**BILLYARD AVE DEVELOPMENTS PTY LTD ATF BILLYARD AVENUE DEVELOPMENT TRUST V  
CITY OF SYDNEY COUNCIL**

**21C Billyard Avenue, ELIZABETH BAY**

**SUPPLEMENTARY JOINT EXPERT REPORT ADDRESSING HEIGHT OF BUILDINGS  
CALCULATION**

Supplementary Joint Expert Report  
Appendix B: Height Plane Amendment

## Wrong Precedent Still Technically Wrong?

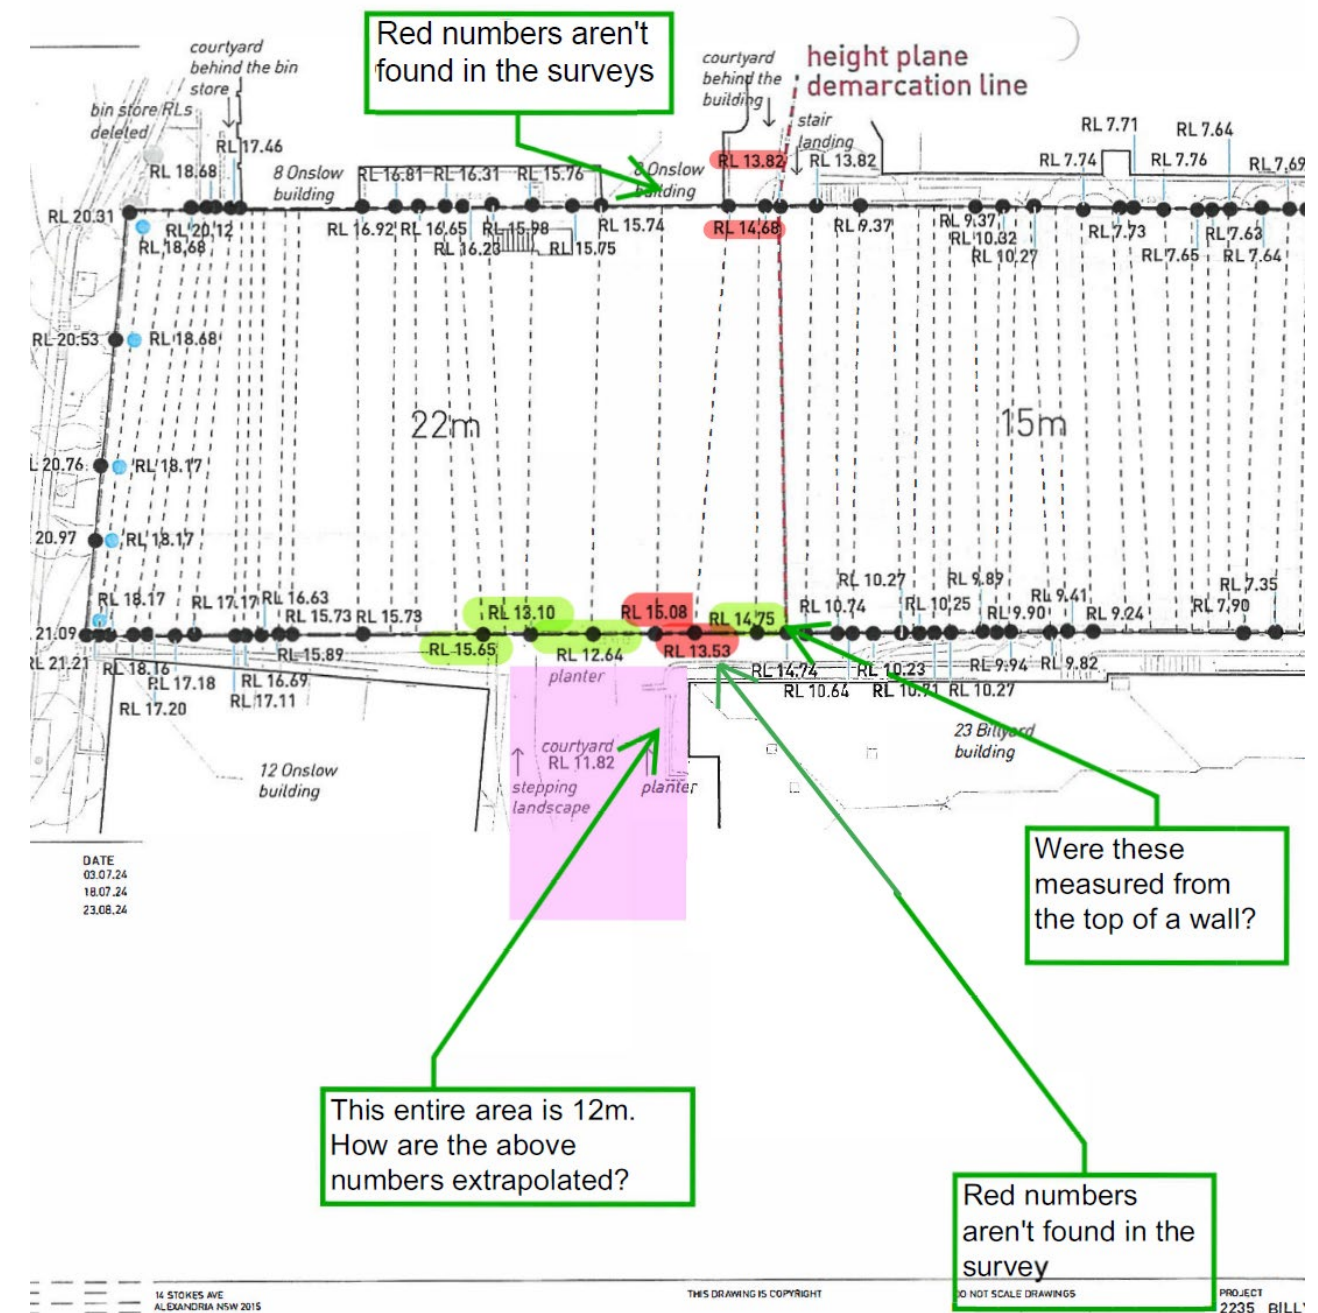
Even when using the wrong precedent, Bettar, they have made confusing assertions.

The measurements they have provided for the site extrapolation do not make sense.

- The extrapolation is supposed to be representative of the conditions on the ground and either side. So why do some measurements appear to be taken from the tops of walls? Instead of the *ground*.
- Why do some measurements quoted not even exist in the survey at all? (red)

## Survey - West Boundary

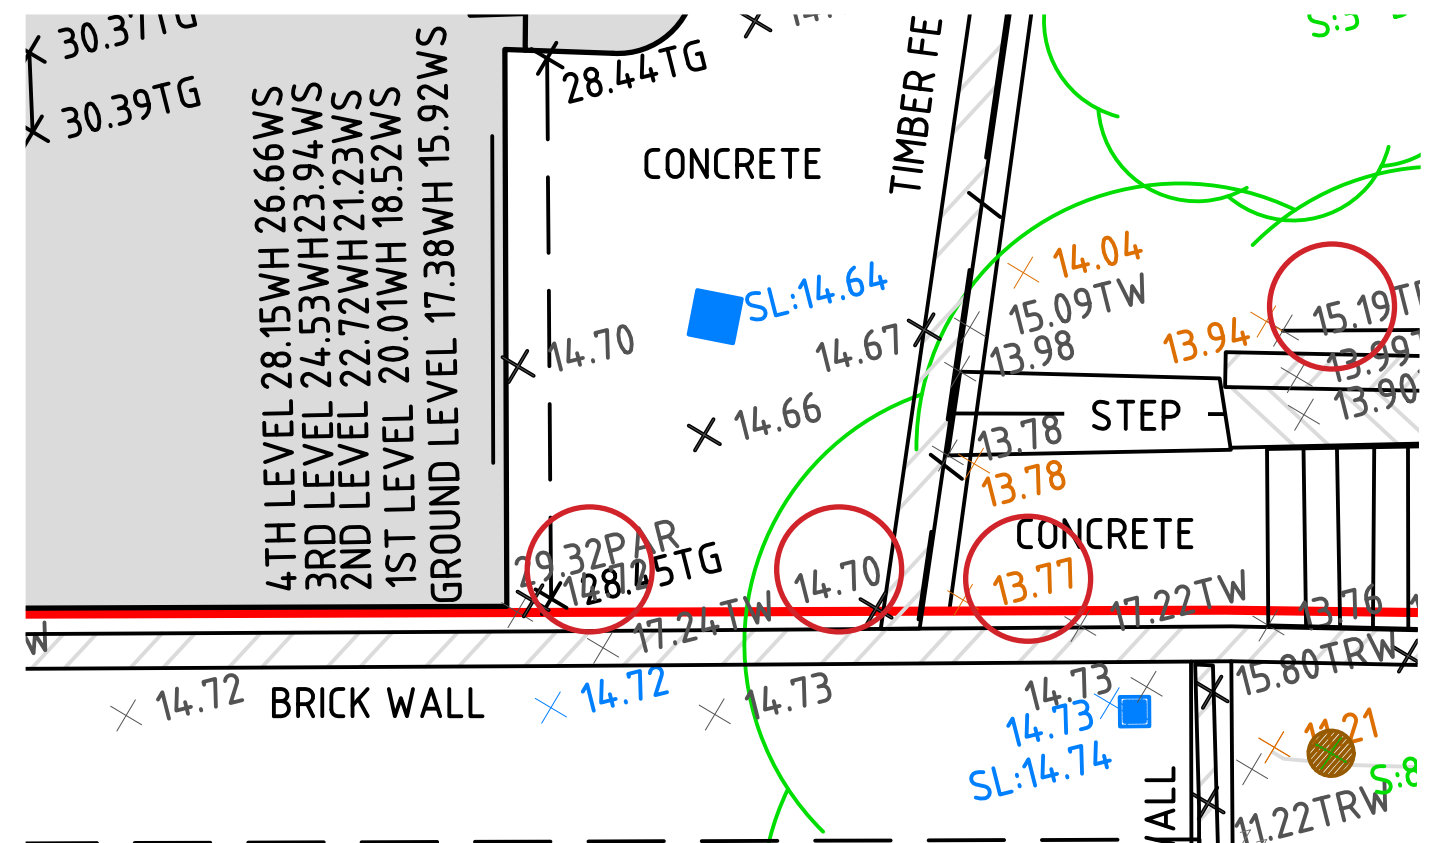
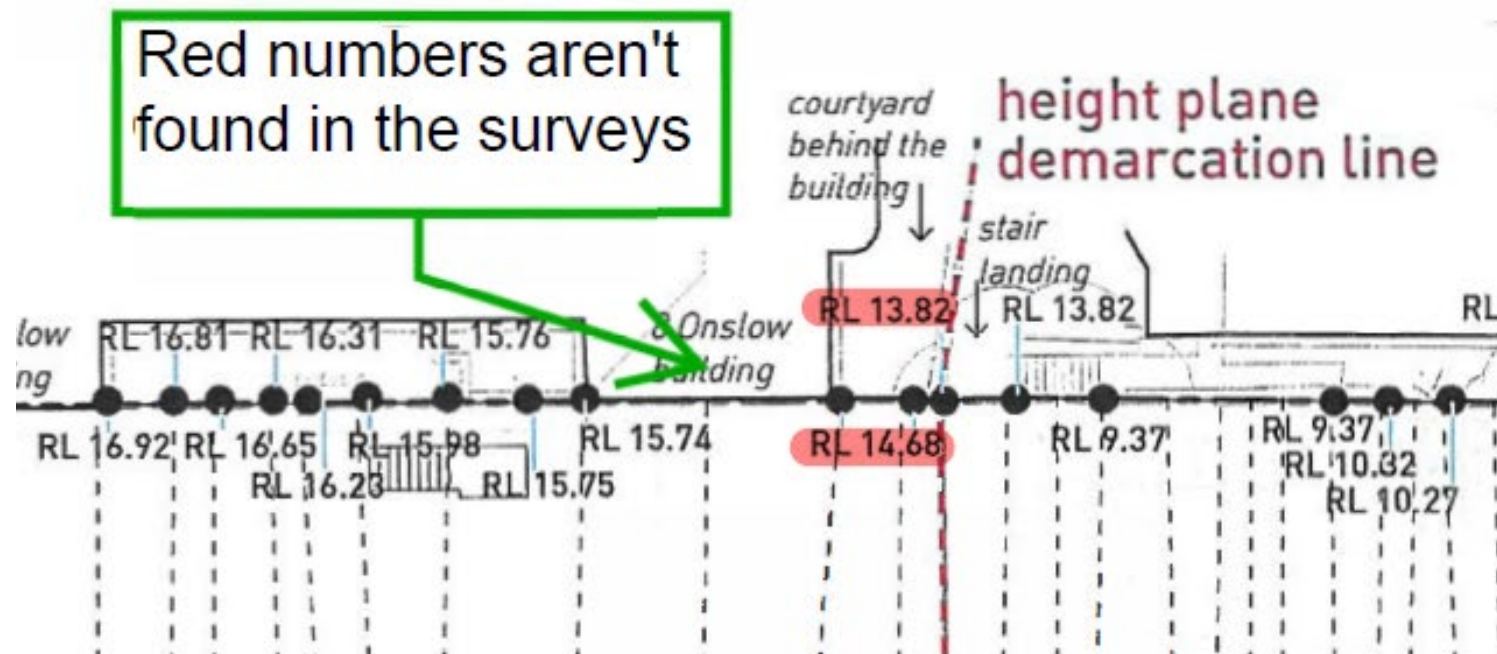
Minor differences between the survey and height plane extrapolation related to differences between the 2D survey and the 3D model.

These differences are extremely minor (between 2cm and 4cm) and do not have any impact on the height plane.

# Survey - East Boundary

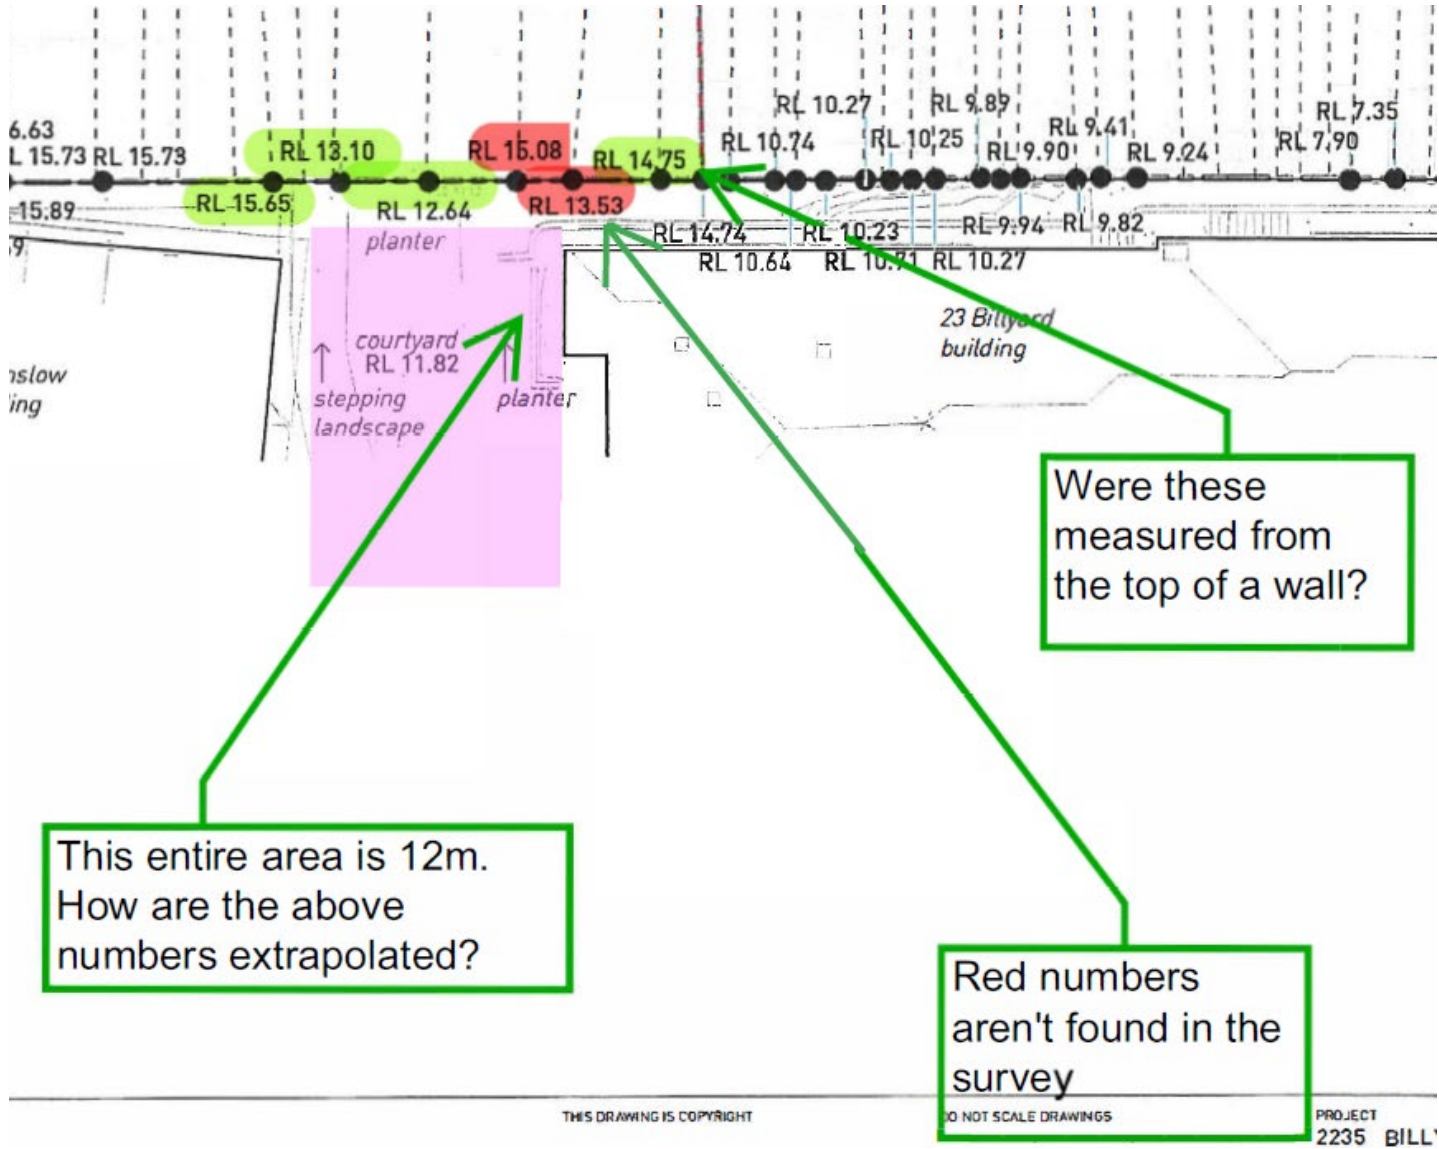
There was an error in two survey points being RL15.08m and RL13.53m, highlighted in red in the Submission.

These points were part of the survey data used to develop and extrapolate the 3D height plane. This was from additional survey information later requested by Council during the Without Prejudice conferencing.

In the updated 2D survey (Ref F dated 05.07.24), these two survey points (RL15.08m and RL13.53m) were deleted, and a new point RL11.82m was added.

This correction to the survey was not clouded nor communicated to the project team and consequently not updated in the 3D height plane extrapolation currently before the Court.

The surveyor has confirmed that those two points were originally incorrectly surveyed and were identified as such when they returned to provide further survey data in July 2024. This is why they were deleted from the survey and a new point added.

Bettar Height Plane - Amended Plan

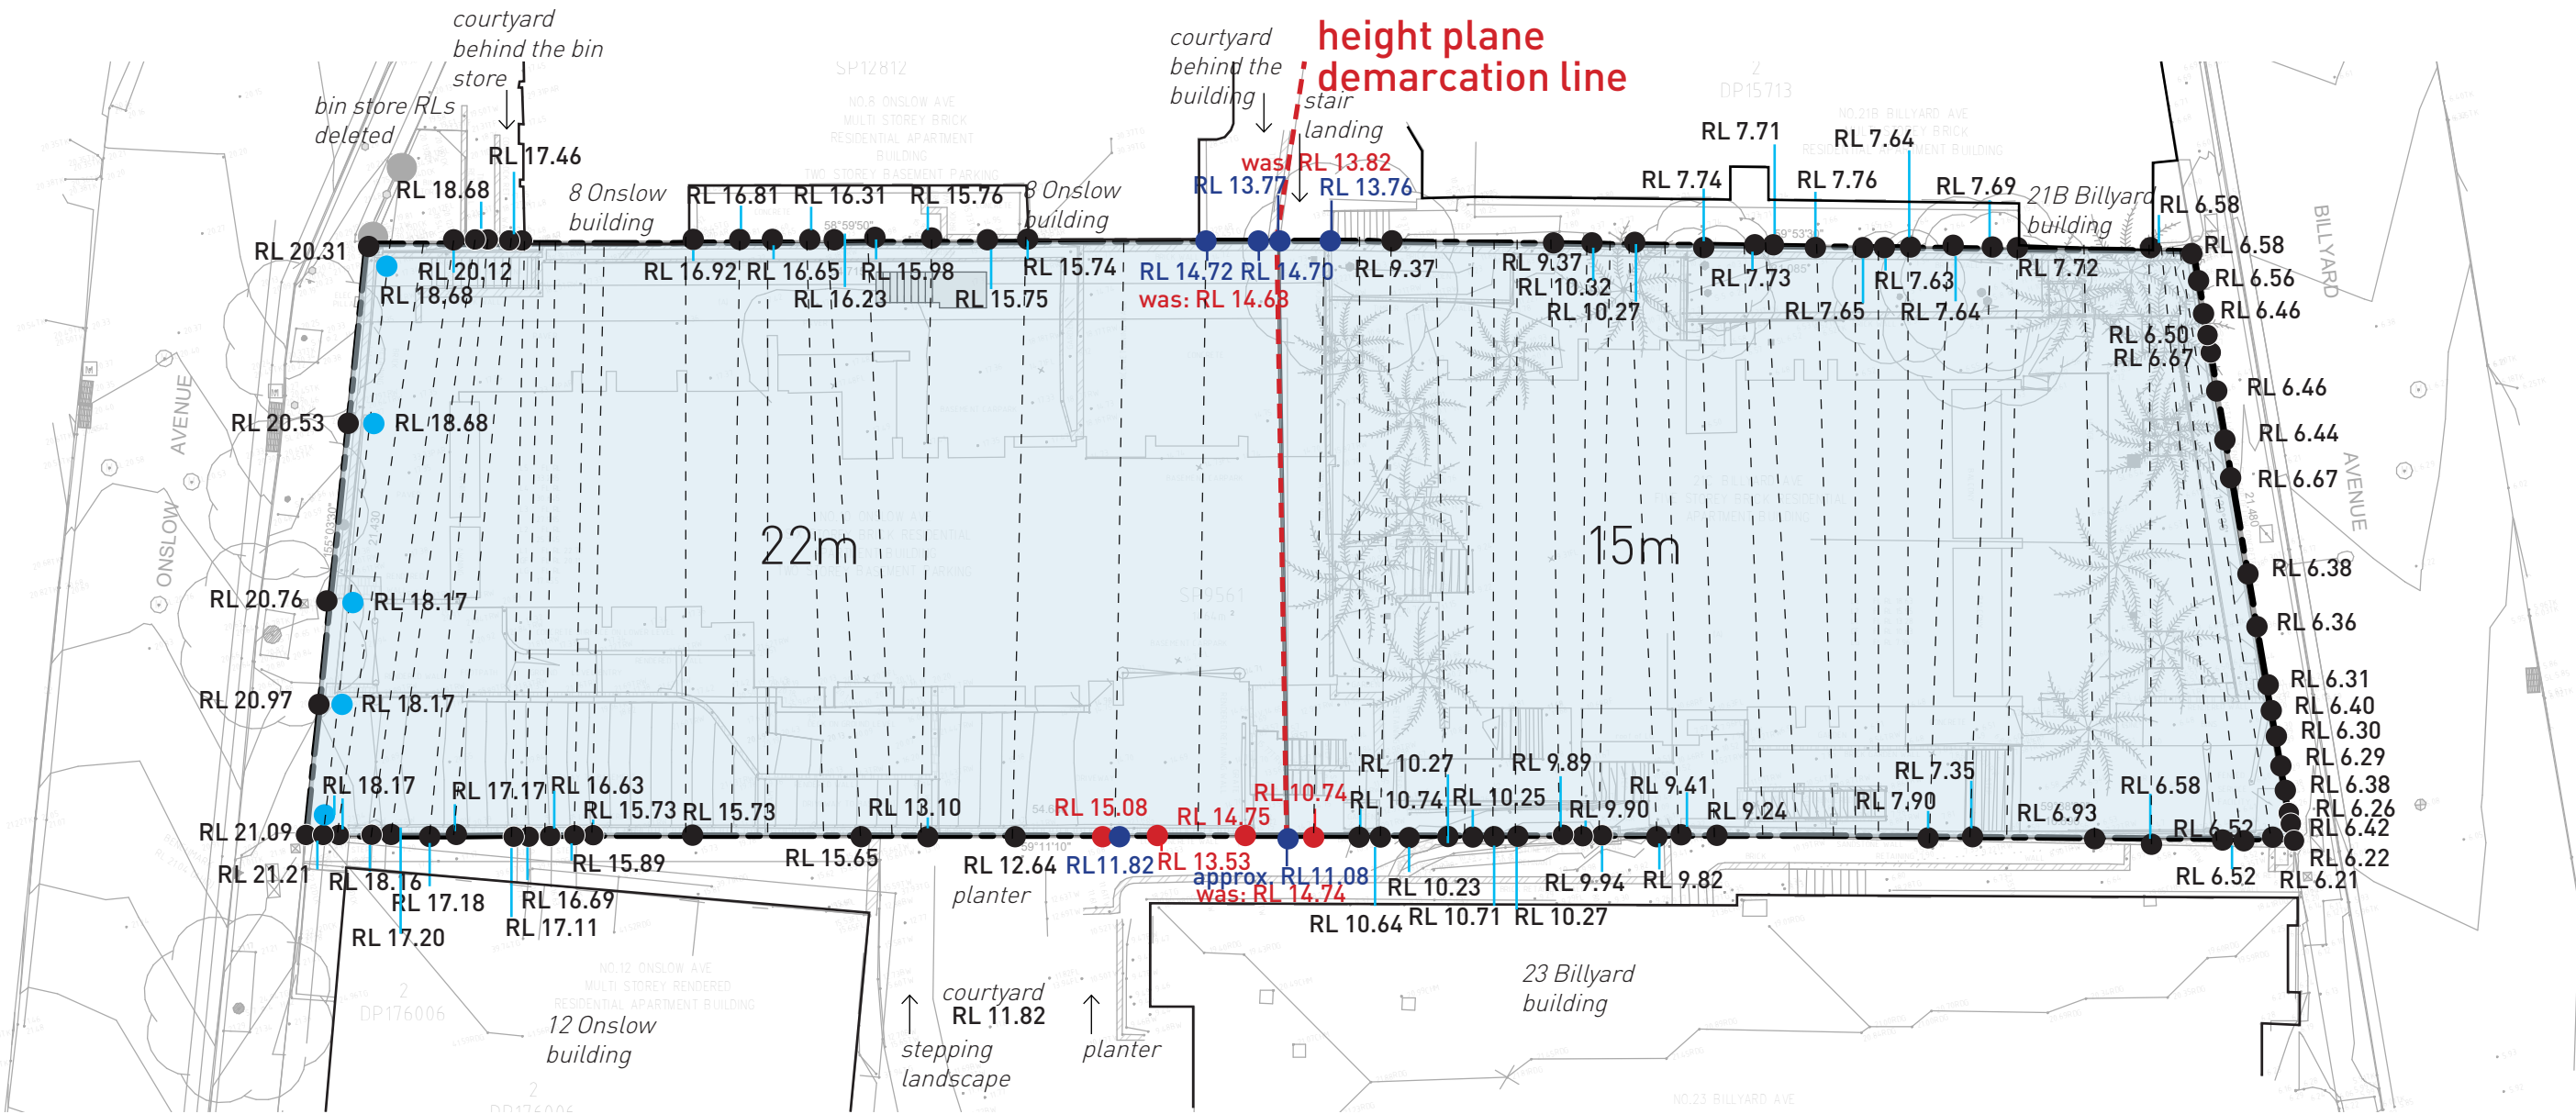
- Removed Points
- Amended Points
